October 19, 2006
RC-06-0190

Subject: VIRGIL C. SUMMER NUCLEAR STATION (VCSNS)
DOCKET NO. 50/395
OPERATING LICENSE NO. NPF-12
SUPPLEMENTAL INFORMATION REGARDING REQUEST TO USE
ALTERNATIVES TO ASME CODE REQUIREMENTS IN VCSNS THIRD
INSERVICE INSPECTION INTERVAL (RR-III-03, RR-III-04)

**SOUTH CAROLINA ELECTRIC & GAS COMPANY (SCE&G)
RESPONSE TO
USNRC REQUEST FOR ADDITIONAL INFORMATION (RAI)
CONCERNING SCE&G REQUEST TO USE ALTERNATIVES
TO
ASME CODE REQUIREMENTS
IN V.C. SUMMER NUCLEAR STATION (VCSNS)
THIRD INSERVICE INSPECTION (ISI) INTERVAL**

- (d) Sketch

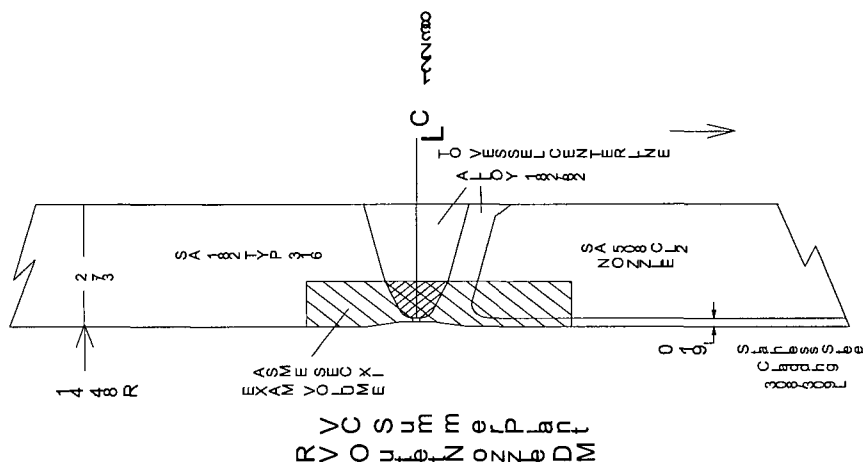
(2) The staff notes that the proposed alternatives in relief requests RR-III-03 and RR-III-04 apply to the inservice inspection of a reactor vessel bravo hot leg nozzle to pipe weld. Provide the following information pertaining to this weld: (a) weld identification number, (b) materials of nozzle, pipe and weld, (c) dimensions of nozzle, pipe and weld including outside diameter and wall thickness, (d) a sketch to show the configuration of the weld joint including the counterbore, weld root condition and other relevant surface condition that would affect the ultrasonic examination.

The counter-bore changes shape from essentially flat to typical indented counter-bore at various angular locations about the inner circumference. Conditions affecting ultrasonic probe contact include counter-bore, root protrusion, suck-back and mis-match. Any surface unevenness can contribute to transducer non-contact.

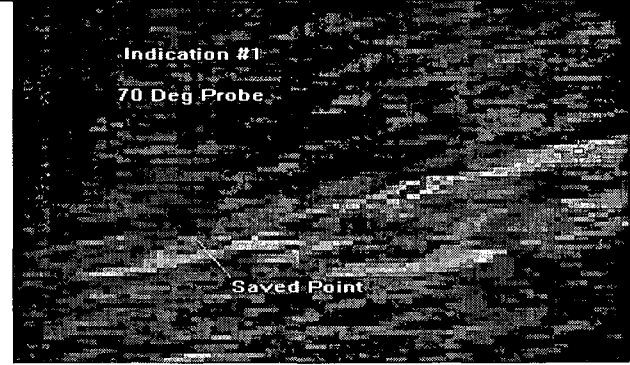
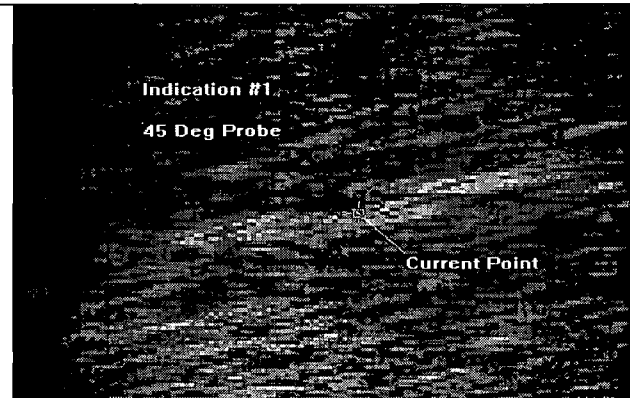
(4) In relief request RR-III-03, you proposed the use of Code Case N-695 with a RMSE of 0.189 inches instead of 0.125 inches for depth sizing. You also stated the examination vendors have qualified for detection and length sizing on these welds except meeting the established root mean square error (RMSE) requirement for depth sizing. However, this is not consistent with the discussion provided in relief request RR-III-04, indicating that the procedures used by the contracted inspection vendor are not fully qualified to the Appendix VIII, Supplement 10 as the procedure is fully qualified only for the detection and length sizing of circumferential flaws. Please clarify the discrepancy regarding the examination vendor's qualification. Since you propose the use of Code Case N-695 which was approved by NRC in Regulatory Guide 1.147, the examination vendor only needs to meet the requirements specified in the subject Code Case. If the statement in relief request RR-III-03 is correct, then the relief request RR-III-04 regarding the potential effect of surface roughness on UT examination is an issue pertaining to meeting the required extent of coverage, not an examiner's qualification issue, and the subject relief request should be modified, accordingly.

For Indication #1, the 70° probe data provided the best estimate of the upper planar flaw boundary and the 45° probe data provided the best estimate of the lower planar flaw boundary. Both points are shown in the beam plots in the Profile View and are documented (Yb and Zb positions) in the left table below the plot. The 'Diff' is the arithmetic difference between the 'Saved' and 'Current' coordinates. The 'Saved' Zb point is the ligament to the ID surface. The through-wall depth of the planar flaw is the 'Diff Zb'. The flaw location is the average between the 'Saved' and 'Current' positions.

A grayscale ultrasonic scan image showing a target motion line. The text "Indication #1" and "70 Deg Probe" is in the upper left. A white arrow points to a point on the motion line labeled "Saved Point".	<p>The 70° probe data shows a target motion line at a depth shallower than the depth with the 45° probe data. Double left clicking on the mouse button with the cursor on the center of the target motion line displays the beam plot in the Profile View corrected for the ID surface contour. This point is then saved on the Profile View. The point is marked on the Profile View by an '+' and the corrected Yb and Zb coordinates are shown in the table below the beam plot as 'Saved'. This point is to be taken as the upper planar flaw boundary.</p>
 A grayscale ultrasonic scan image showing a target motion line. The text "Indication #1" and "45 Deg Probe" is in the upper left. A white arrow points to a point on the motion line labeled "Current Point".	<p>The 45° probe data shows a deeper target motion line indicative of the lower planar flaw boundary. Double left clicking on the mouse button with the cursor on the center of the target motion line displays the beam plot in the Profile View corrected for the ID surface contour. The point is marked as the end of the line emanating from the probe. The corrected Yb and Zb coordinates are shown in the table below the beam plot as 'Current'. This point is taken as the lower planar flaw boundary.</p>
